CABINET MEMBER FOR ENVIRONMENT – 26 MARCH 2020 EAST HANNEY – A338 – PROPOSED PUFFIN CROSSING

Report by Director for Infrastructure Delivery, Communities

3. This report presents responses received to a statutory consultation to introduce a puffin crossing on the A338 at East Hanney.

Plan of proposed puffin crossing Consultation responses Background papers:

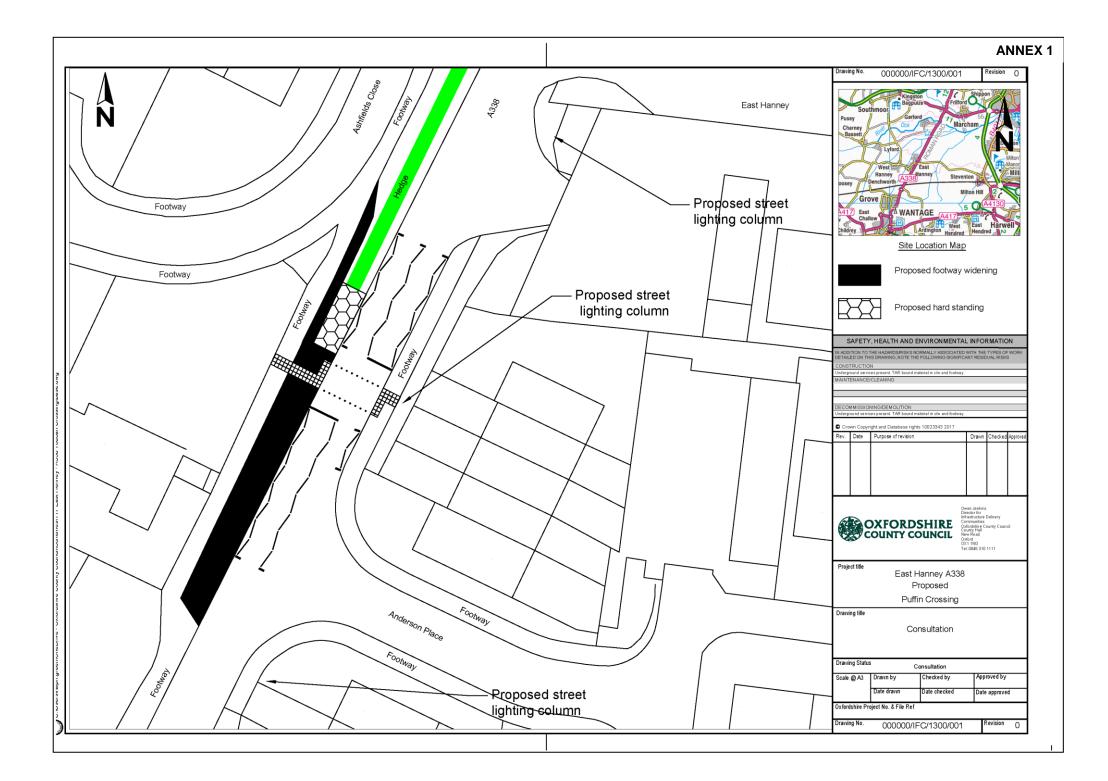
- 9. One objection was received from a local resident citing concerns that a signalled crossing would be less safe than an uncontrolled option, suggesting that children in particular who relied on the green pedestrian signal may be vulnerable if drivers failed to comply with a red signal. There were concerns over the proximity of side road junctions and potential increase in noise and air pollution from vehicles stopping then accelerating.

- 10. Expressions of support were received from fifteen parties including two local groups and thirteen members of the public.
- 11. Two supporters of the crossing queried (and a further actually objected to) the proposed footway widening with consequent grass verge and hedge loss to the north of the crossing and the forfeiture of its screening and noise reduction provision. There were also several concerns over the increase in lighting pollution.

- 13. Suggestions were also made to review the signing for an adjacent business premise and remove a traffic island to improve visibility.
- 14. In the light of comments received it is proposed to implement the pedestrian crossing.

(7) Local Resident, (Wantage)	Support - I support the installation of a signalised crossing at this location, but I would like to raise an objection over the large area of verge that is shown on the map as being tarmaced over.				
	East Hanney is a rural village and therefore large expanses of tarmac are out of place along what is currently a grass verge and hedge.				
	Can the footway be widened only to a width that leaves a grass verge along the side of the road, as I also believe that without suitable prevention methods, such as wooden posts, the large area of tarmac will quickly be used as a car

(15) Local Resident, (East Hanney)	Support - I am generally in favour of a safer road crossing. I have minor concerns that the proposed site is not close enough to the bus stops and people will still cross the road further north, close to Ashfields Lane. I am also unclear as to the purpose of the proposed "hard standing". Is it to be incorporated into the widening of the footpath or is it for another purpose? As shown on the plan it looks like a car parking space and that would be wholly inappropriate. I would hope that the proposed lighting would be as discrete as possible and at as low an intensity as possible so as not to affect the nearby houses or the generally unlit nature of the village.

- 12. The hedge removal will be required to meet visibility standards, especially critical with the open nature of the site and high prevailing vehicle speeds. The lighting improvements are also required to meet design standards although the design will be as sensitive as possible.
